Addendum 3

Clarifications

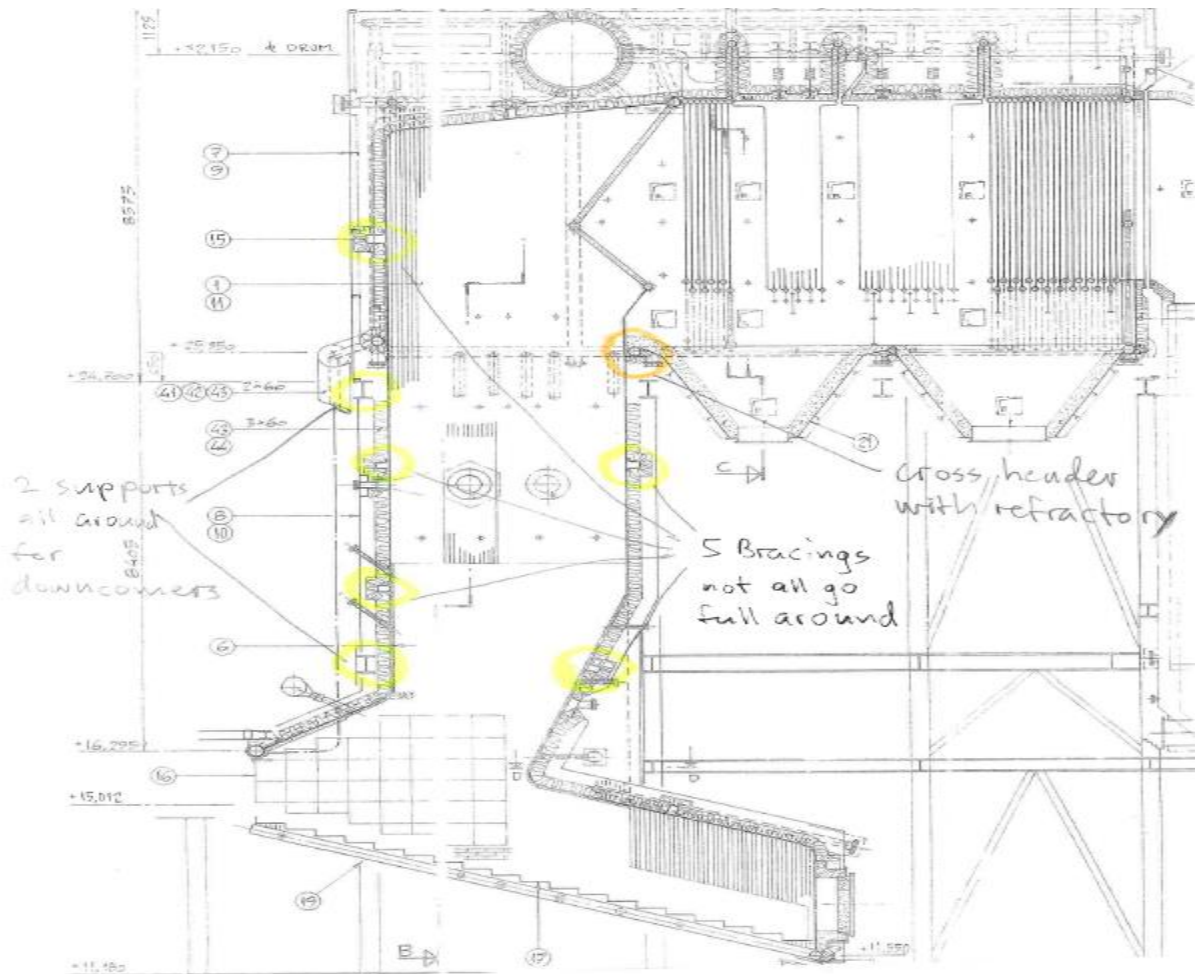
1. Please take note of the supports and bracing which have been highlighted. The bracing will need to be removed when performing the waterwall replacement for Unit #2. Note: This bracing and supports hold the weight of the boiler furnace. The insulation and refractory in these areas will need to be replaced after testing.
